**TOWN OF NEWBURGH  
PLANNING BOARD  
REVIEW COMMENTS**

**PROJECT:** WTF NY LOT LINE CHANGE  
**PROJECT NO.:** 14-07  
**PROJECT LOCATION:** SECTION 2, BLOCK 1, LOTS 42 & 46  
**PROJECT REPRESENTATIVE:** TALCOTT ENGINEERING DESIGN, LLC  
**REVIEW DATE:** 27 MARCH 2014  
**MEETING DATE:** 3 APRIL 2014

**LOT LAYOUT**

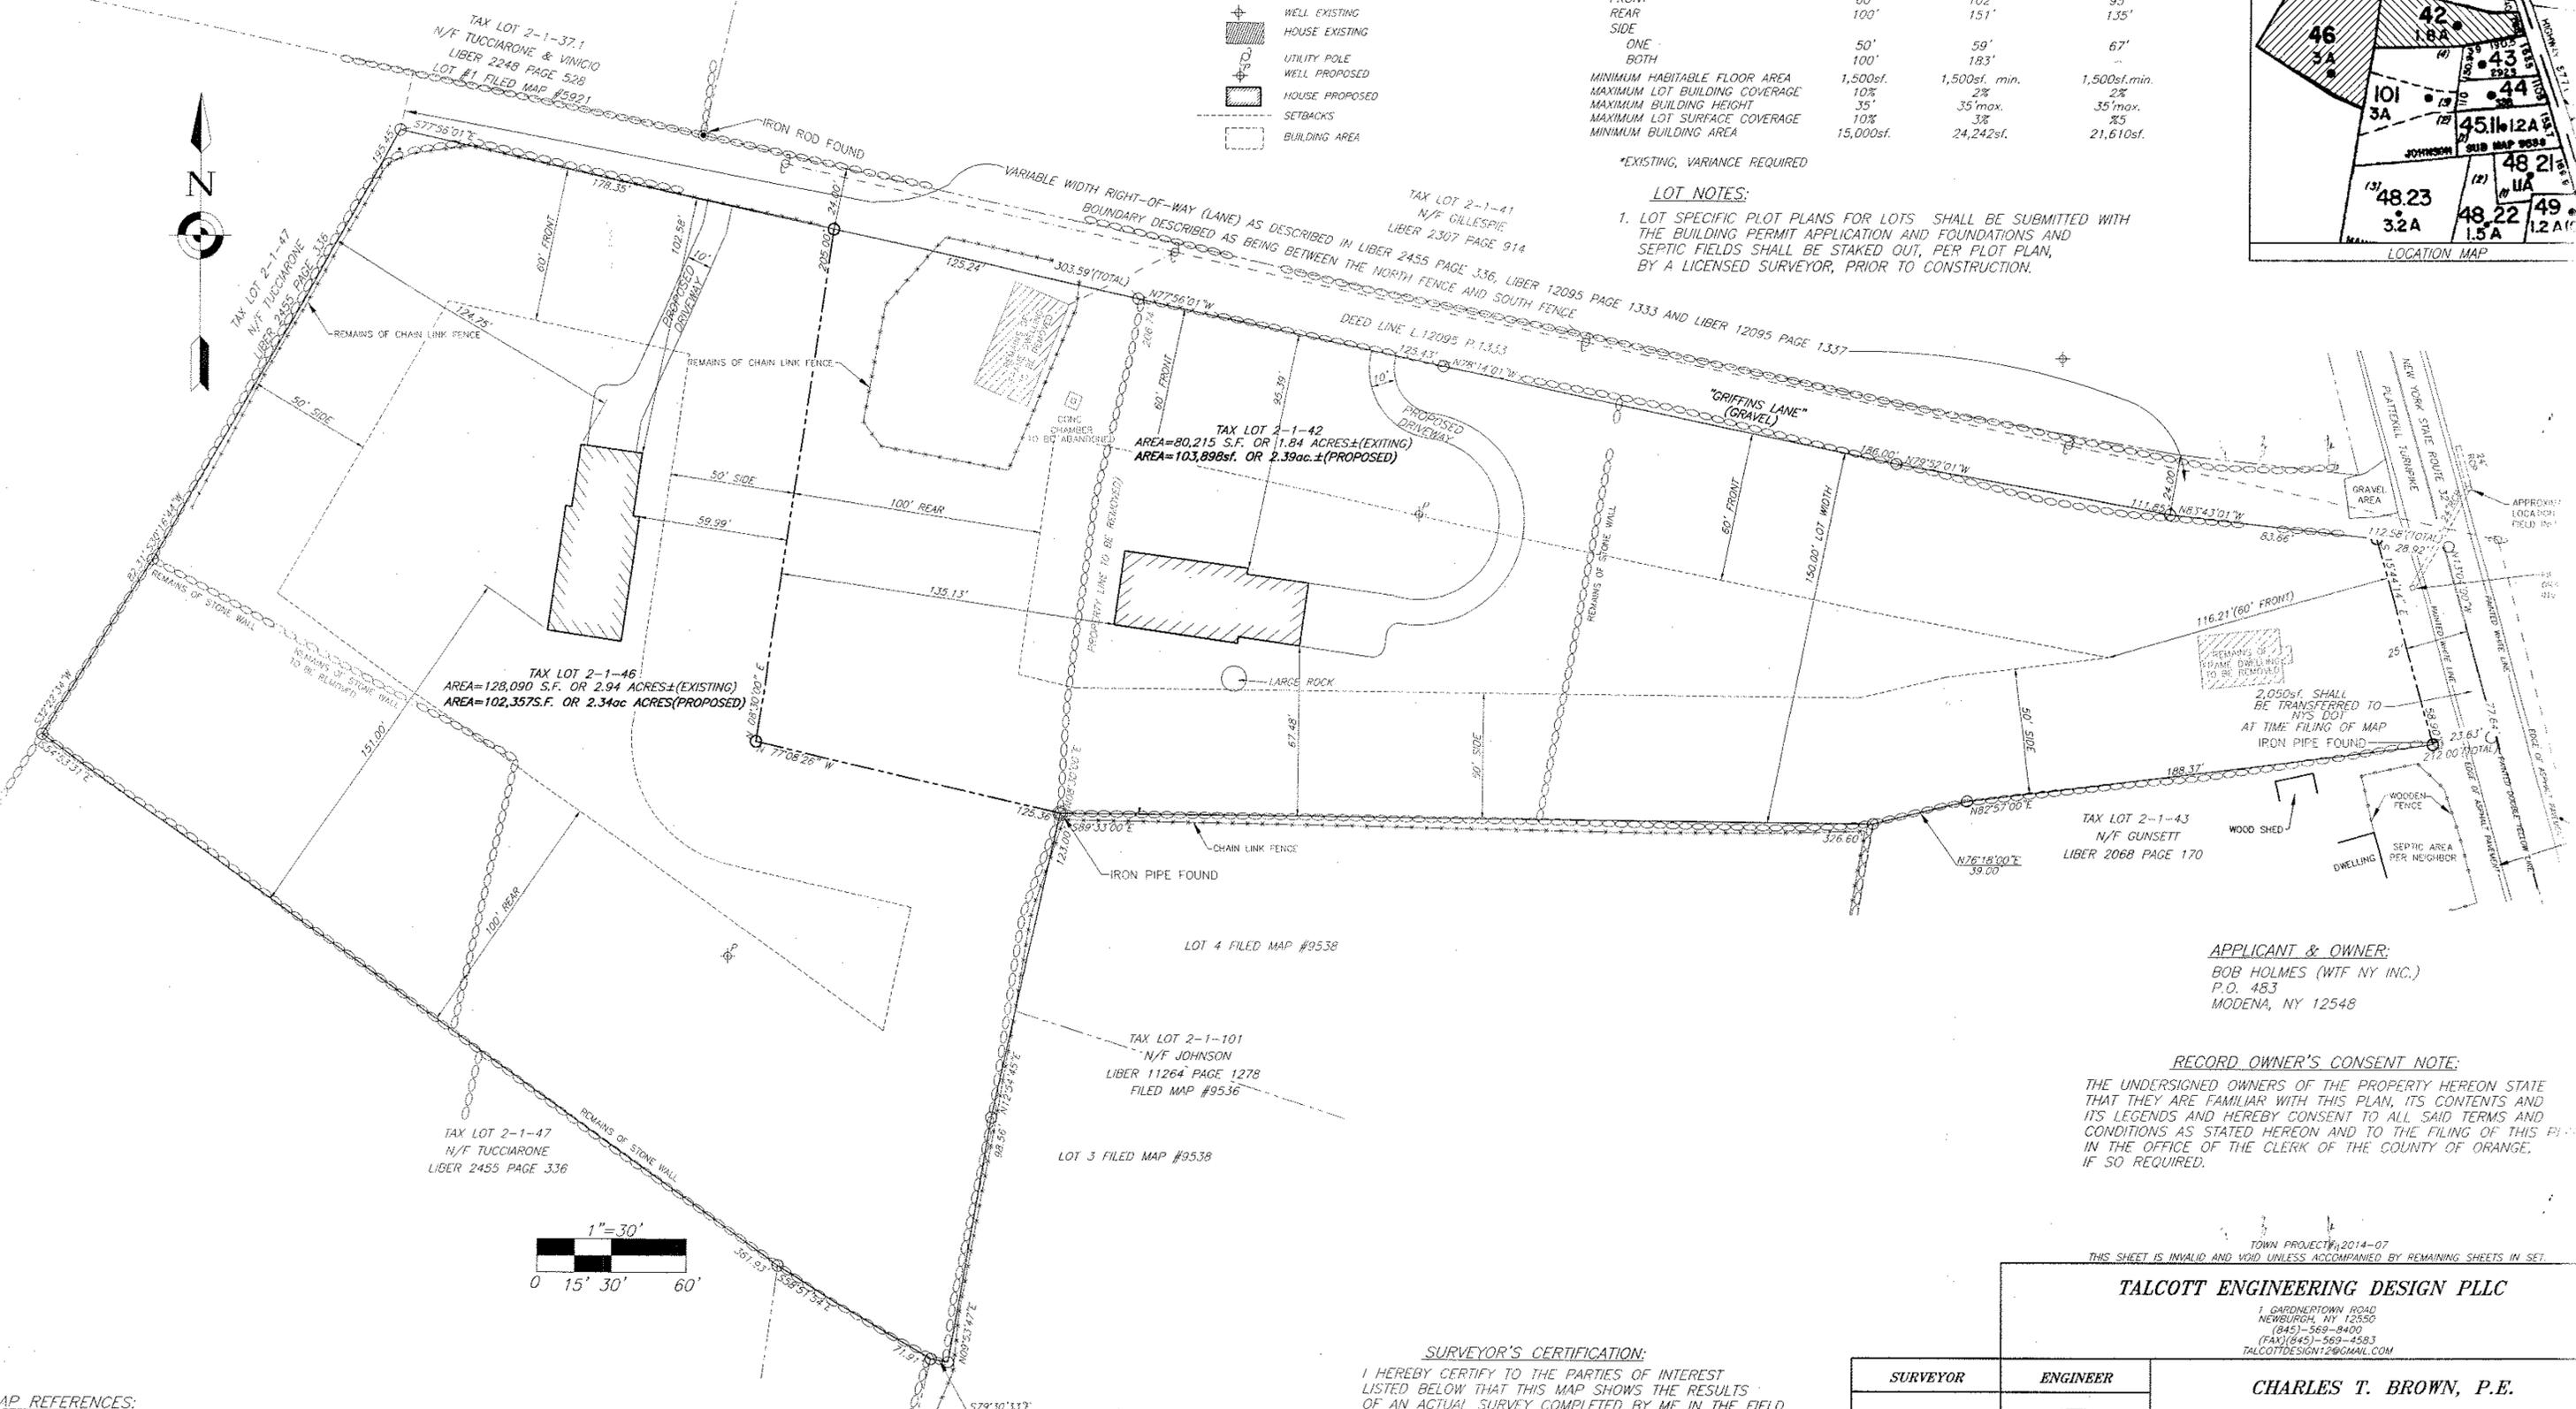
1. Project involves the proposed transfer of .6 acres of property between two adjoining lots. Each of the resulting lots will meet the lot area requirements for the existing zone. Tax Lot 42 does not meet the lot width requirements of the RR Zone, which is 200 feet, less than 200 is provided.

2. Buildable area must be depicted on each lot in compliance with zoning regulations.
3. Status of the roadway identified as Griffins Lane should be discussed. It is identified as a right of way, unclear if it is considered an existing private road. Information pertaining to the status of Griffins Lane should be submitted to Mike Donnelly's office for review.

ENGINEER	<b>CHARLES T. BROWN, P.E.</b> P.O. BOX 4470 NEW WINDSOR, N.Y. 12553		
SEPTIC & GRADING			
LOT LINE CHANGE FOR: <b>WTF NY INC.</b> 979 & 983 NYS ROUTE 32 SBL: 2-1-42&46 TOWN OF NEWBURGH, ORANGE COUNTY, NY			
DATE 03/25/14	SCALE 1"=20'	JOB NUMBER 13072-WTF	SHEET NUMBER 2 OF 3

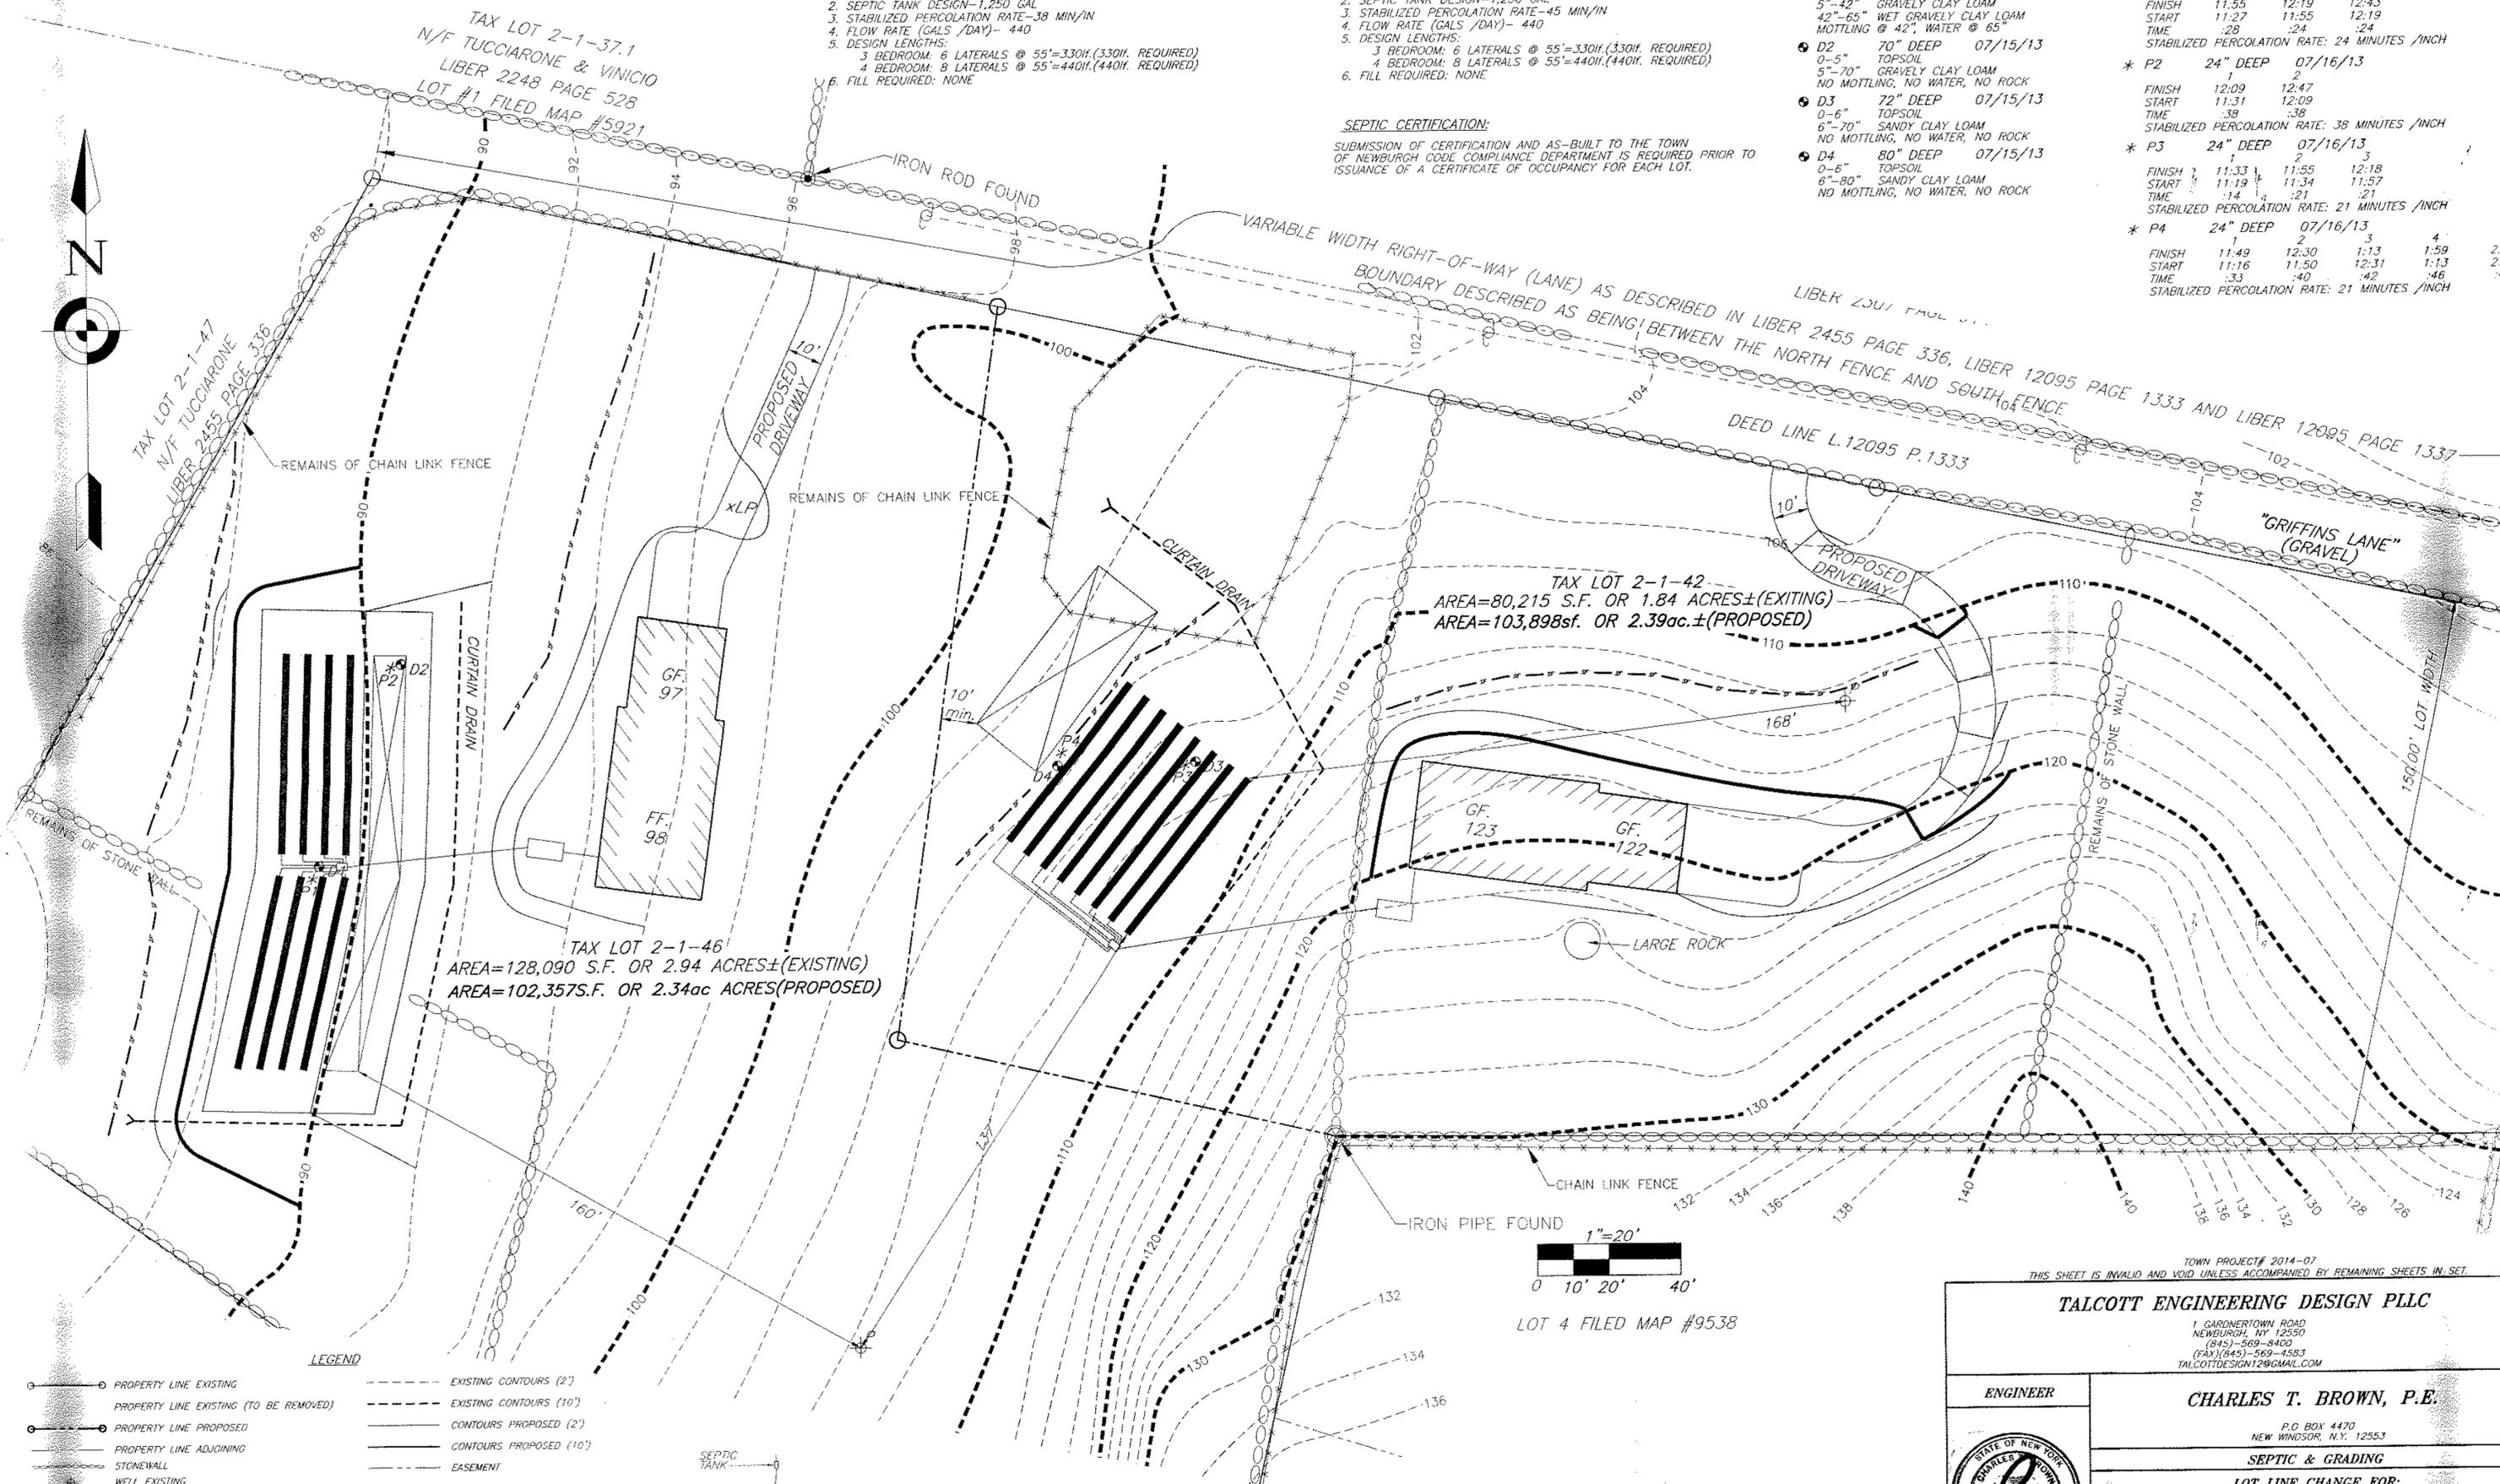
4. Sanitary Sewer System proposed for Lot 46 appears to be a shallow absorption trench system which should be clearly identified on the plans. It is noted the septic design criteria does not identify fill required.
